Randolph County Historic Courthouse Museum Renovation & Elevator Addition: Addendum #1

ADDENDUM #1:

This Addendum No. 1 forms a part of the Contract Documents and modifies the original documents dated June 1, 2023, as noted below. Acknowledge receipt of this addendum in the space provided on the Bid Form.

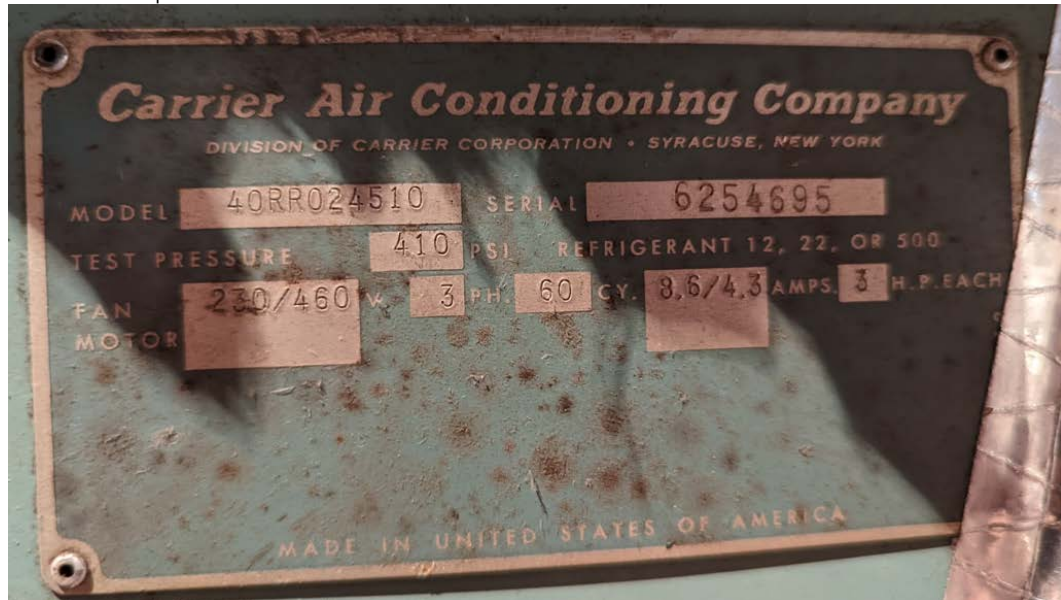
6. Question: Are model numbers available for the existing HVAC units?
 - o Response: See below for a photo of the existing attic unit. We do not have model numbers for the rooftop outdoor unit.
